MILITARY
SPECIFICATION

MIL-A-55101A(SigC)
Amendment 1
4 February 1964

ANTENNA AT-912( )/VRC

FIGURE IV

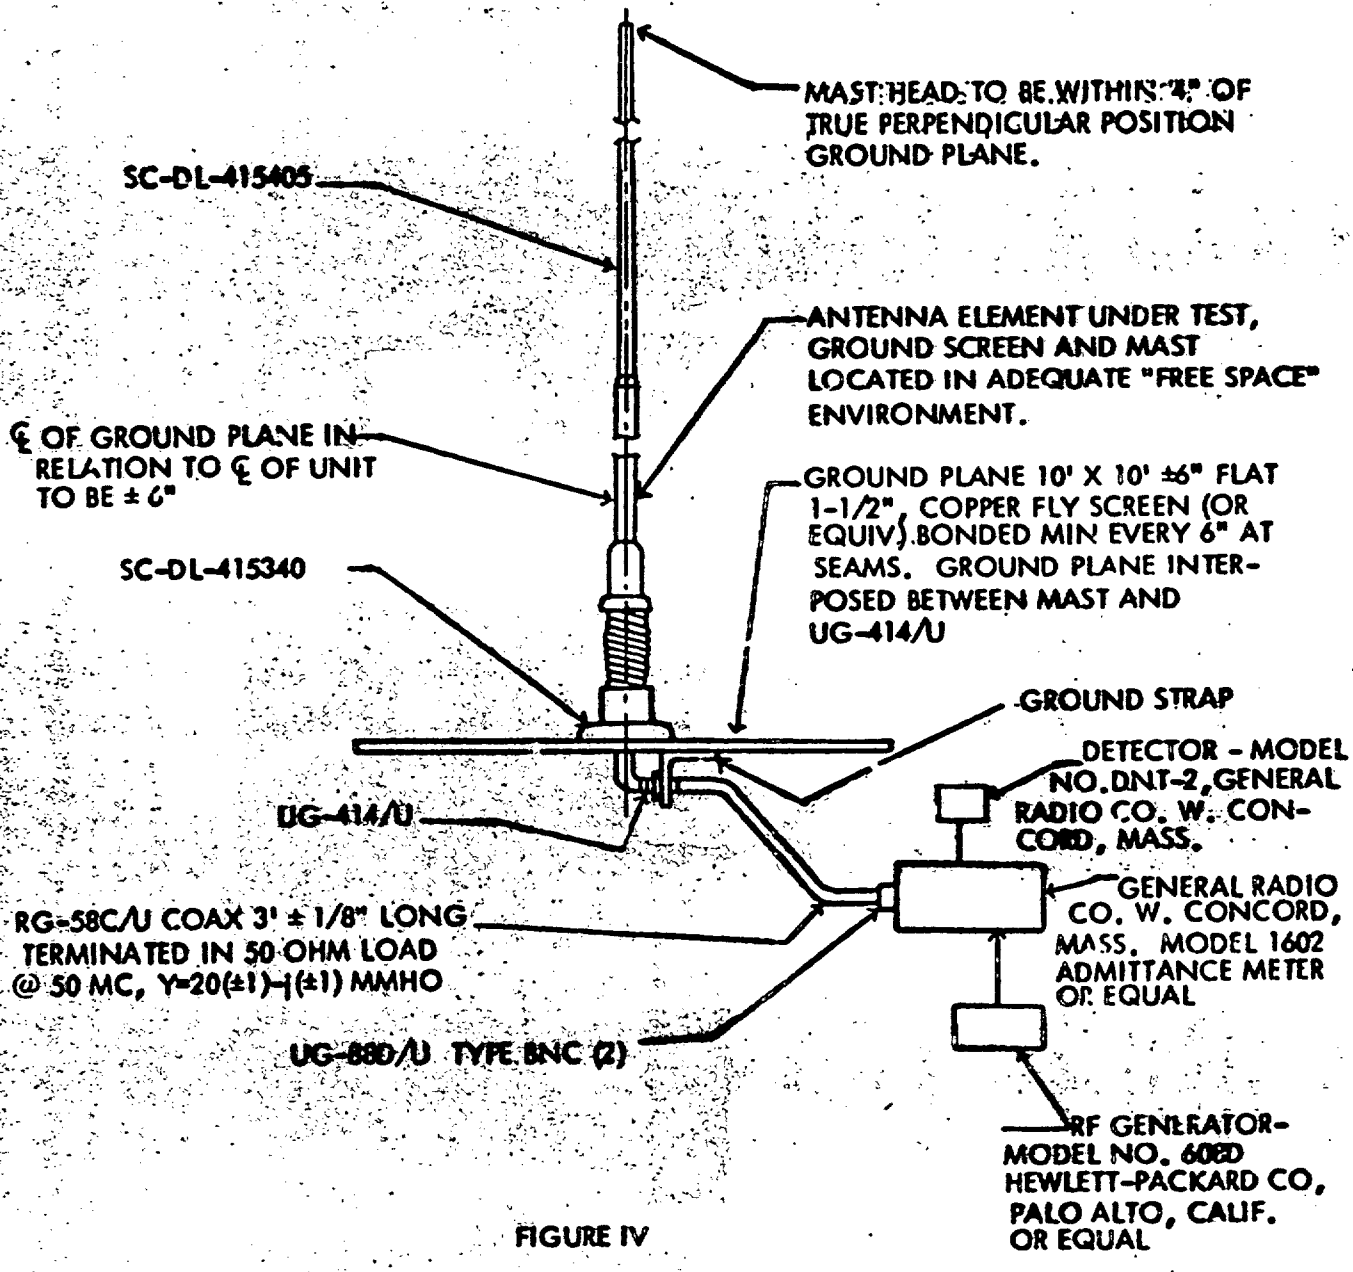
7. Sheet 23, add Paragraph 4.9.6.3:

4.9.6.3 Admittance test (see 3.16.7).- When the admittance of the assembly is measured in accordance with Figure IV the requirements of 3.16.7 shall be met.

FIGURE 4

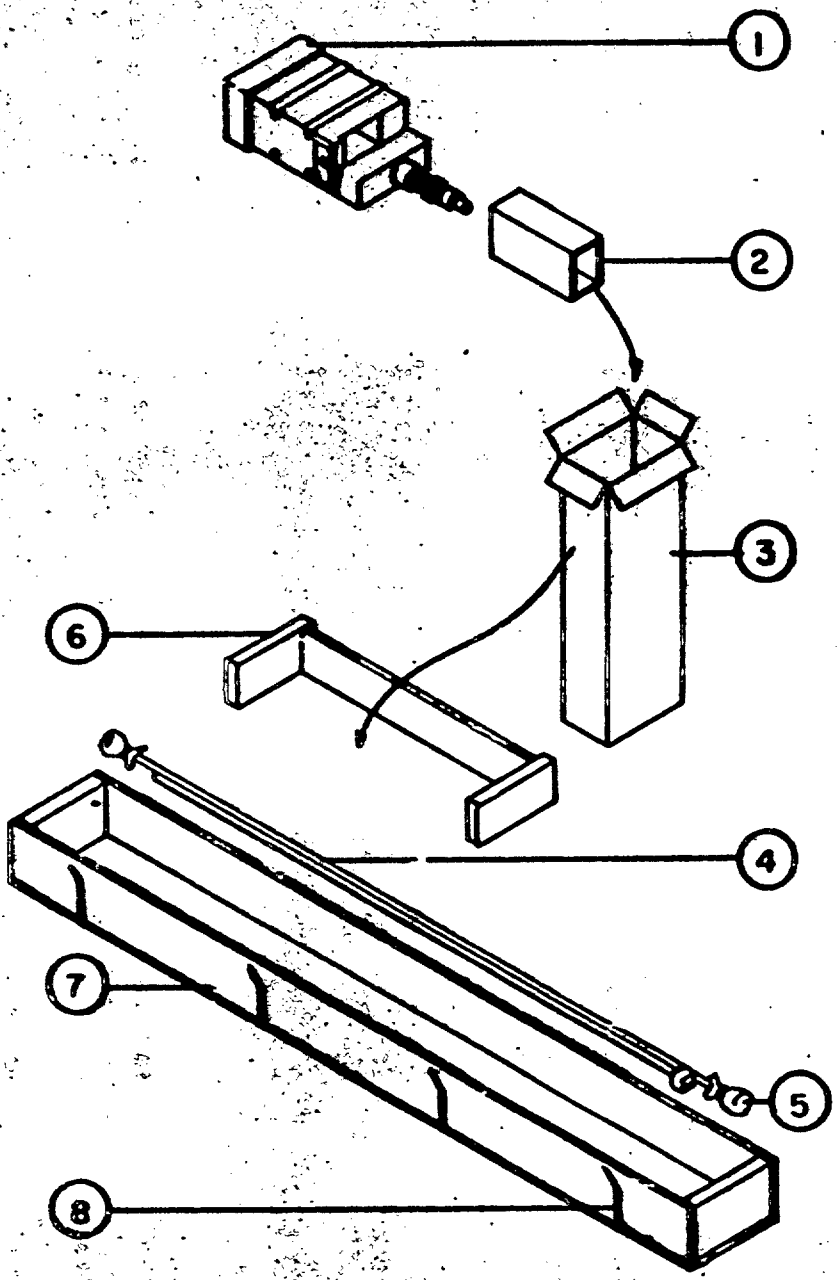
5.1.1 Level A.- Each Antenna AT-912( )/VRC shall be packaged in accordance with Items 1 through 7 of Figure V and Table I and IA. Box closure of Item 7 shall be as specified in the Appendix of the applicable box specification.

5.2.1 Level A.- Each Antenna AT-912( )/VRC shall be packed in accordance with Item 8 of Figure V and Table IA.
